ion. LOT 456, Cnr Grand Boulevard & Shenton Ave, Joondalup The Perth Diocesan Trustees & Perth Radiological Clinic

Proposed Chapel & Offices / Medical Suites

## DESIGN ADVISORY PANEL NOTES OF MEETING HELD ON MONDAY 30 NOVEMBER 2009

# ITEM 1 PROPOSED OFFICES, RESTAURANT, PLACE OF WORSHIP, AND MEDICAL CENTRE AT LOT 466 (57) SHENTON AVENUE, JOONDALUP [04723]

Site & Ground Floor Plan (AHD 50,500)

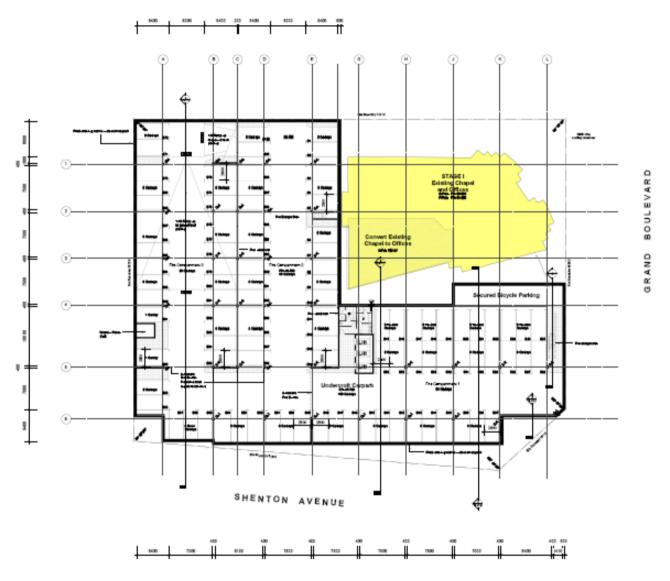
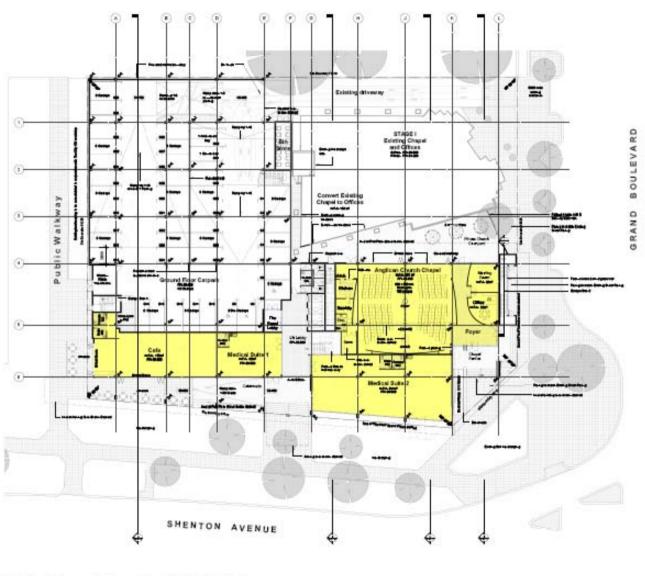
- Noted that the development addresses the hard built edges expected of a
  development in a City Centre, however, queried whether sufficient consideration had
  been given to maximise the activation of the building, particularly along Central Walk
  and to a lesser extent, how the chapel addresses Grand Boulevard.
- Noted the retention of the existing building on the site presents specific challenges when addressing the space between the existing and proposed building.
- Queried whether the design presented enough of a landmark quality given the importance of the site.
- Noted that the development incorporates the use of ramps and steps, querying whether alternative designs were considered to address the principle of dignity of access.

- Additional consideration being given to the activation of walkway and street frontages, especially Central Walk;
- Amenity for persons utilising courtyard area, particularly in relation to the amount of natural light in the area due to roof overhang. It is suggested that the applicant be required to provide a shadow diagram, demonstrating the amount of light penetration in this area:

- Provision of bicycle parking within public realm;
- Awnings to be wrapped further around the building, along the Central Walk façade.
   This should extend to the corner of the car park;

- It is suggested that the front entrance design be revisited in order to address dignity concerns for persons unable to use the stairs.
